ADA Curb Ramp New Construction Inspection Form (Perpendicular)

311th North-South Road Name 24952.54 Project No. Sheet No. Intersection No. Kaybern East-West Road Name

Ramp Style PR

PERPENDICULAR RAMP (PR)

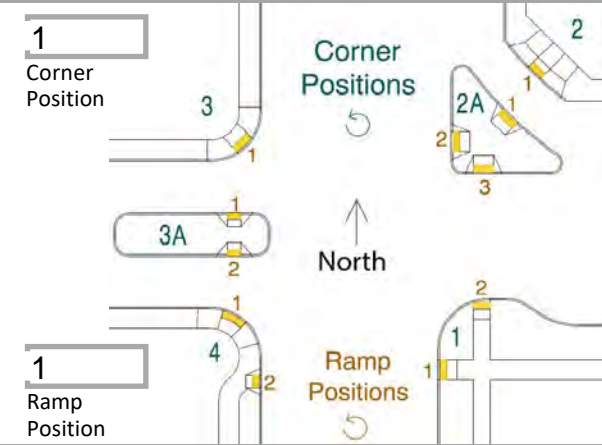
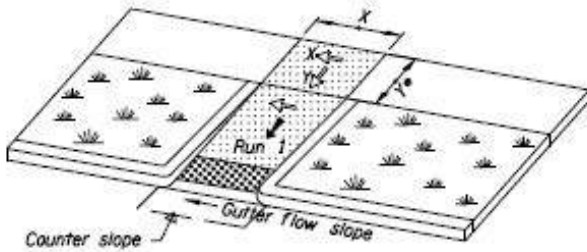
IITD, gt2. Lip at front of TD
